RE: **Lot 7 Block 1 Volcano Cliffs Unit 22 SAD 228**
8020 Alto Rey Ct. NW
Grading and Drainage Plan
Engineers Stamp Date 10/21/2020 (D10D003N7)
Pad Certification Dated: 5/10/2021

Based upon the information provided in your submittal received 6/25/2021, this plan is approved for Building Permit.

**Re: Pulte at Volcano Cliffs Unit 18
Erosion and Sediment Control Plan
Engineer's Stamp Date 6/17/2021 (D10E003_P)**

SHEET TITLE:
GRADING AND
DRAINAGE PLAN

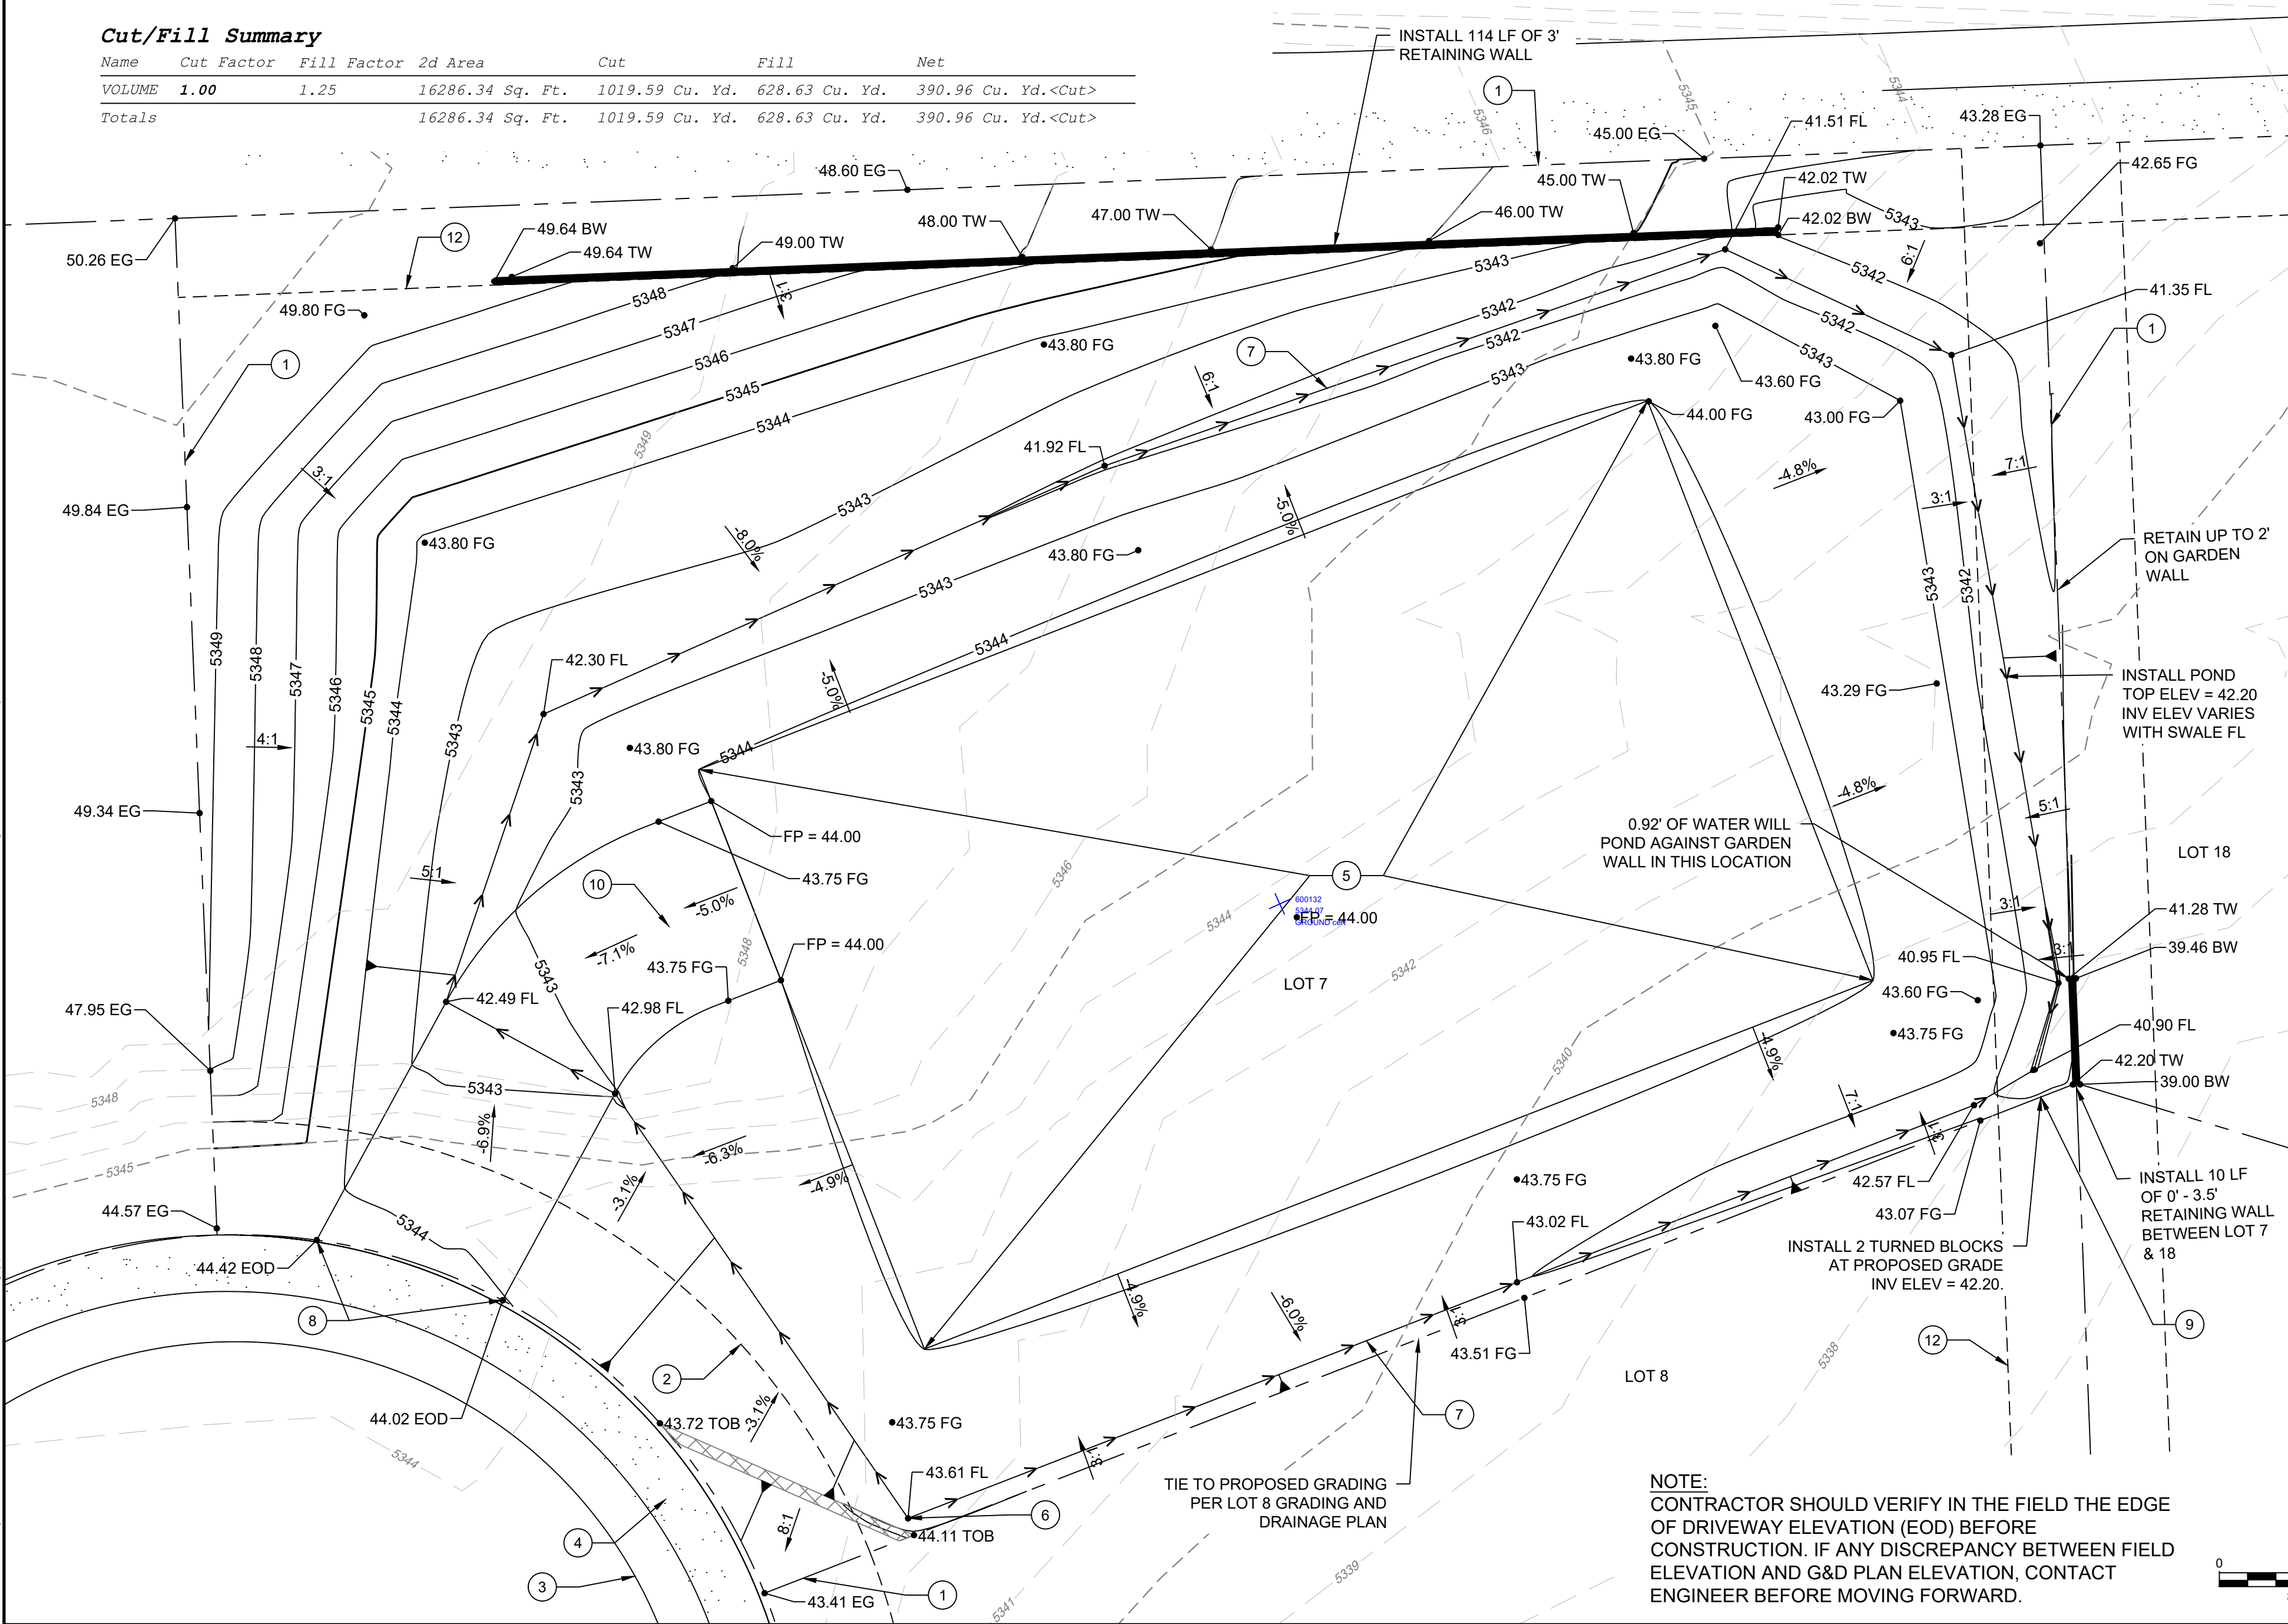
Reiterate to the Owner/Contractor that a separate permit for a garden/retaining wall must be obtained with the approved G&D plan and Pad Certification. **Also, if a swimming pool is to be placed the grading and drainage plan will change and will need to be resubmitted showing location of pool and land treatment changes.**

Prior to Certificate of Occupancy release, Engineer Certification per the DPM checklist will be required.
